BHARAT HEAVY ELECTRICALS LIMITED
PROJECT ENGINEERING MANAGEMENT, NOIDA

CORRIGENDUM- 02

PROJECT	:	2X490 MW NTPC DADRI STAGE-II-FGD SYSTEM
PACKAGE	:	HVAC for FGD
ENQUIRY NO	:	E-5948/2018 Dated 22.05.2018
SUBJECT	:	TECHNICAL AMENDMENT + DUE DATE EXTENSION

ANNEXURE-1

Guaranteed Power Consumption For Air Conditioning System

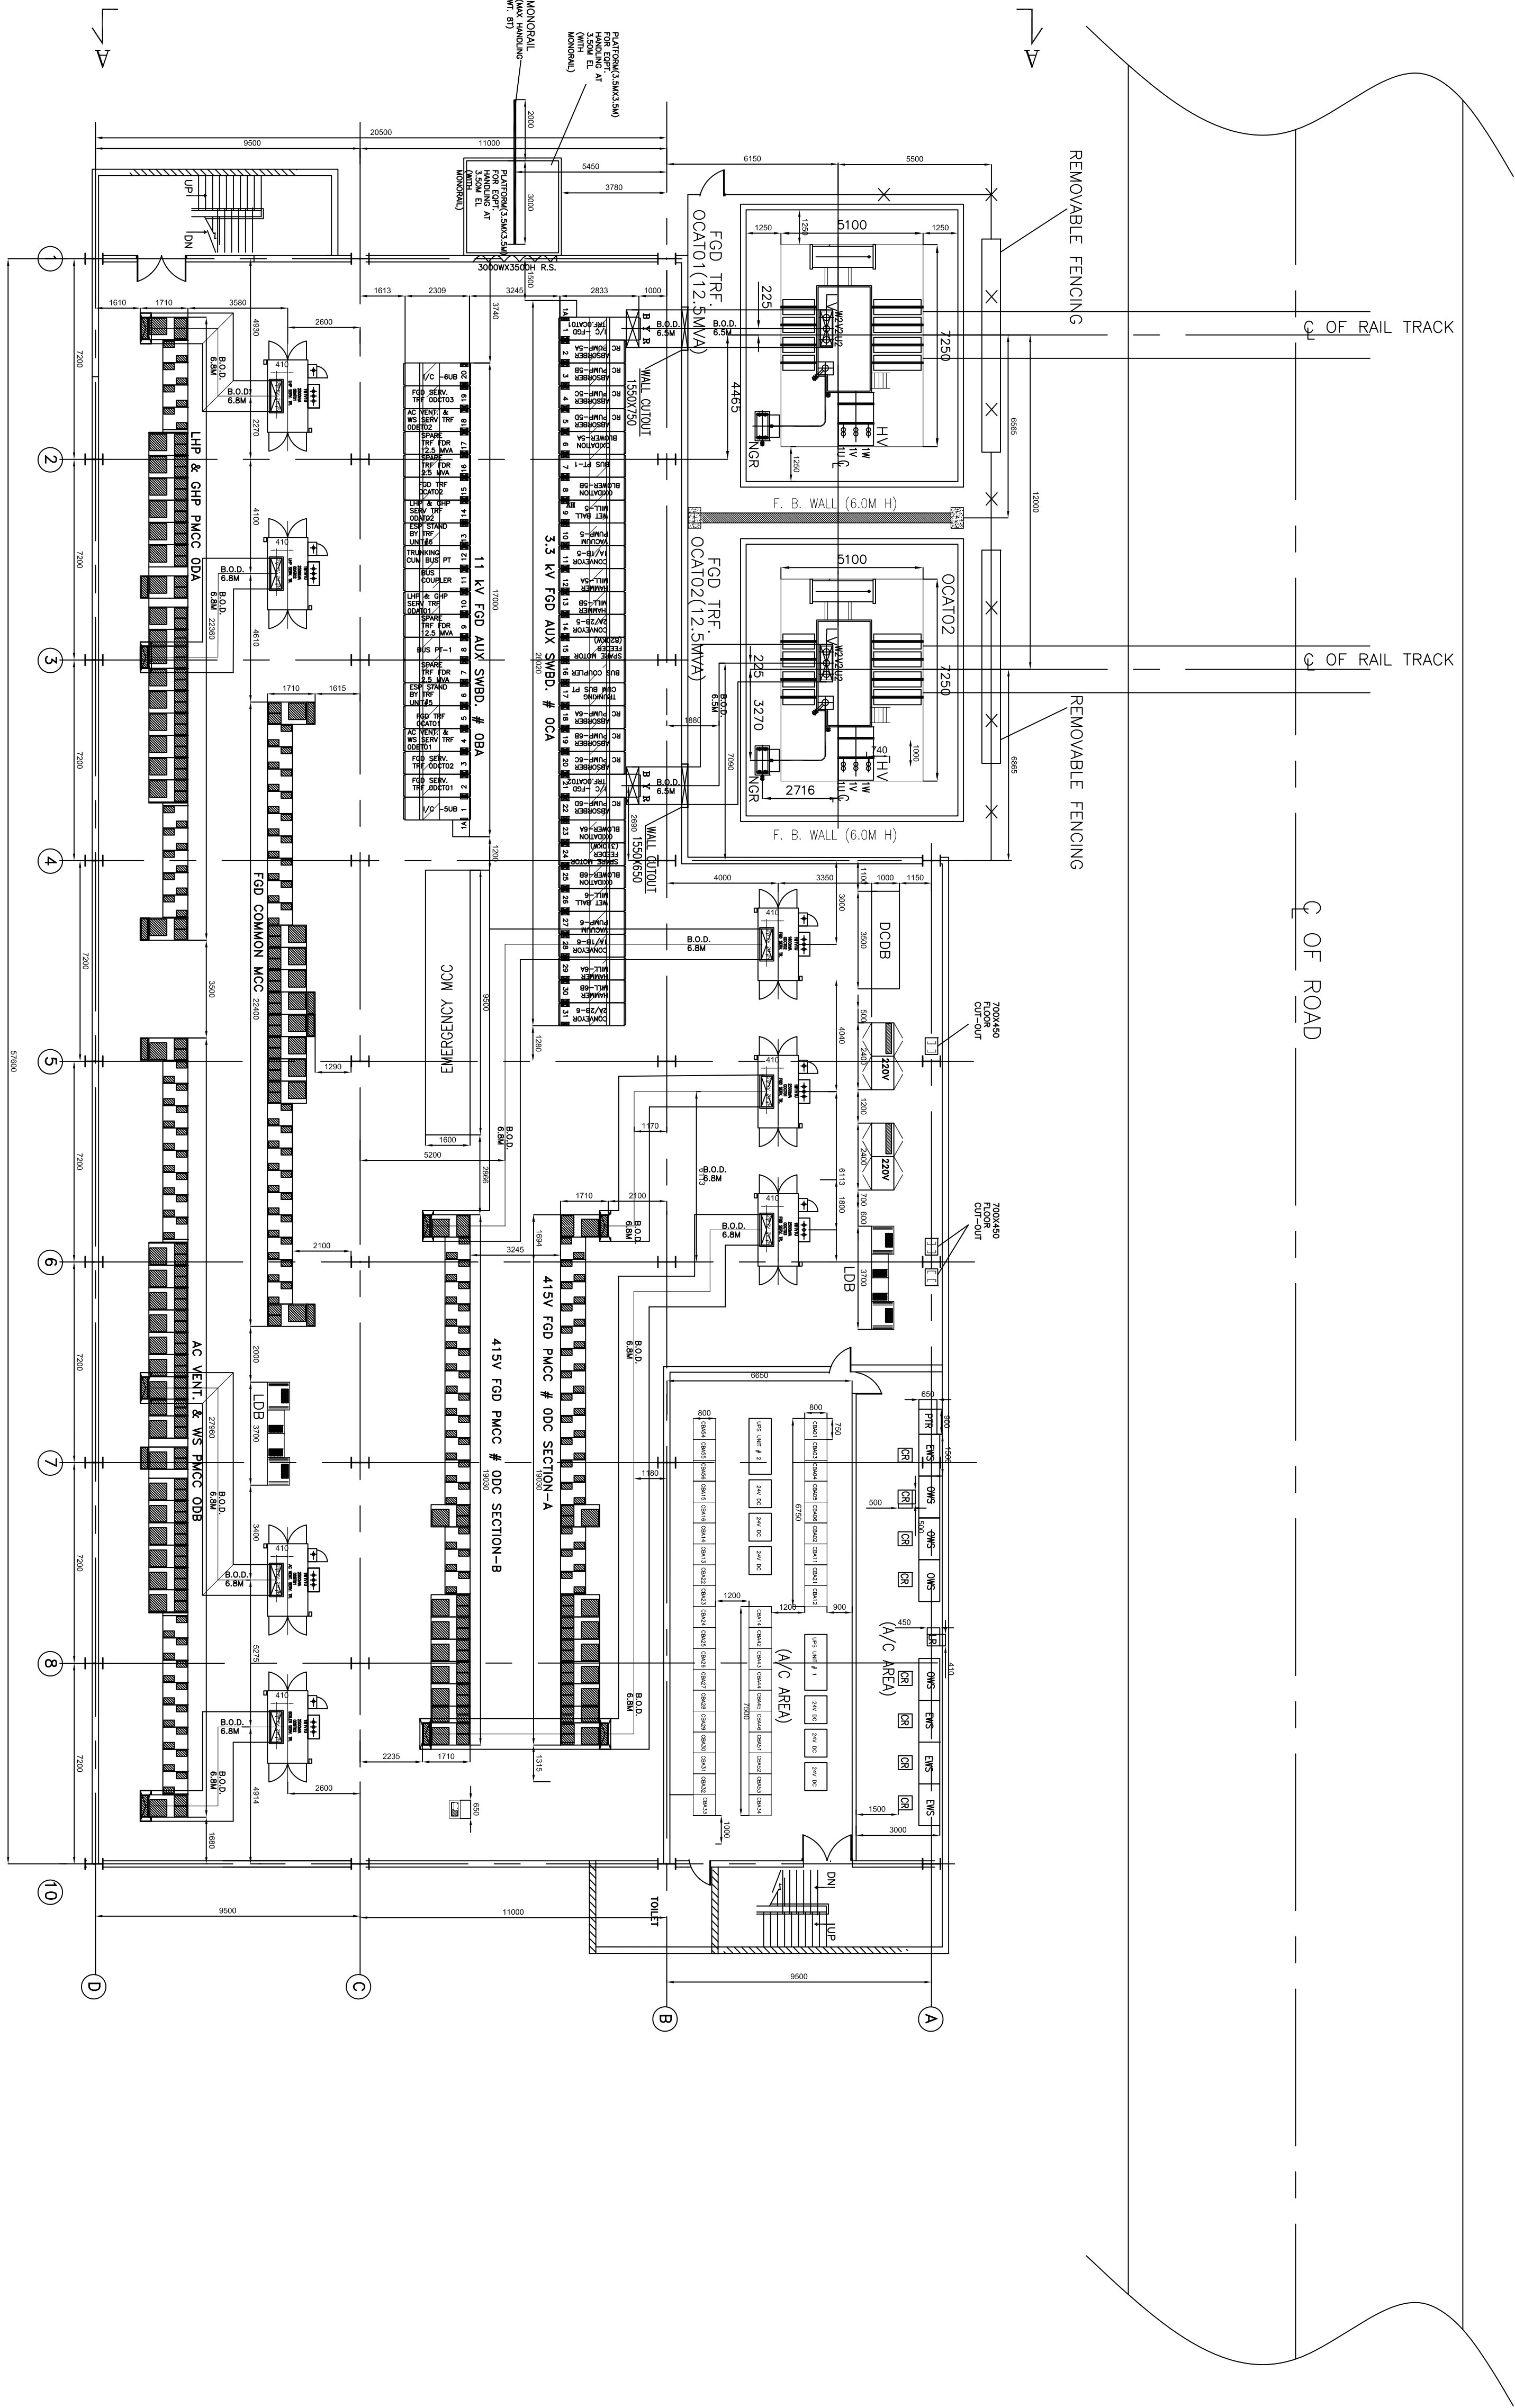
3	SECTION : II, SUB-SECTION : 6 of technical specification and other relevant clauses of complete technical specification.	Estimated power consumption (EPC) figure for the system (for working drives only) has been considered as 79.5 KW. So long bidder's quoted guaranteed power consumption (GPC) above remains within this EPC, there will be no technical loading of bid on power	Estimated power consumption (EPC) figure for the system (for working drives only) has been considered as 90.5 KW . So long bidder's quoted guaranteed power consumption (GPC) above remains within this EPC, there will be no technical loading of bid on power consumption for

consumption for evaluation. However, if bidder's quoted GPC exceeds EPC, there shall be technical loading of bid for evaluation @ Rs 1, 97,080/-per KW of additional power over EPC. Bidder's guaranteed power consumption at motor input terminals (not shaft power) as furnished in relevant schedule shall be demonstrated by the successful bidder during performance testing at works/site. In case power consumption is noted higher than EPC / bidder's quoted GPC whichever is higher, during inspection/ PG test, penalty @ Rs 1,97,080/- per KW shall be levied on vendor.	evaluation. However, if bidder's quoted GPC exceeds EPC, there shall be technical loading of bid for evaluation @ Rs 1, 97,080/- per KW of additional power over EPC. Bidder's guaranteed power consumption at motor input terminals (not shaft power) as furnished in relevant schedule shall be demonstrated by the successful bidder during performance testing at works/site. In case power consumption is noted higher than EPC / bidder's quoted GPC whichever is higher, during inspection/ PG test, penalty @ Rs 1,97,080/- per KW shall be levied on vendor.

Note: Estimated power consumption (EPC) figure for the system (for working drives only) has been considered as 90.5 KW. So long bidder's quoted guaranteed power consumption (GPC) above remains within this EPC, there will be no technical loading of bid on power consumption for evaluation. However, if bidder's quoted GPC exceeds EPC, there shall be technical loading of bid for evaluation @ Rs 1, 97,080/-per KW of additional power over EPC.

Bidder's guaranteed power consumption at motor input terminals (not shaft power) as furnished in relevant schedule shall be demonstrated by the successful bidder during performance testing at works/ site. In case power consumption is noted higher than EPC / bidder's quoted GPC whichever is higher, during inspection/ PG test, penalty @ Rs 1,97,080/- per KW shall be levied on vendor.
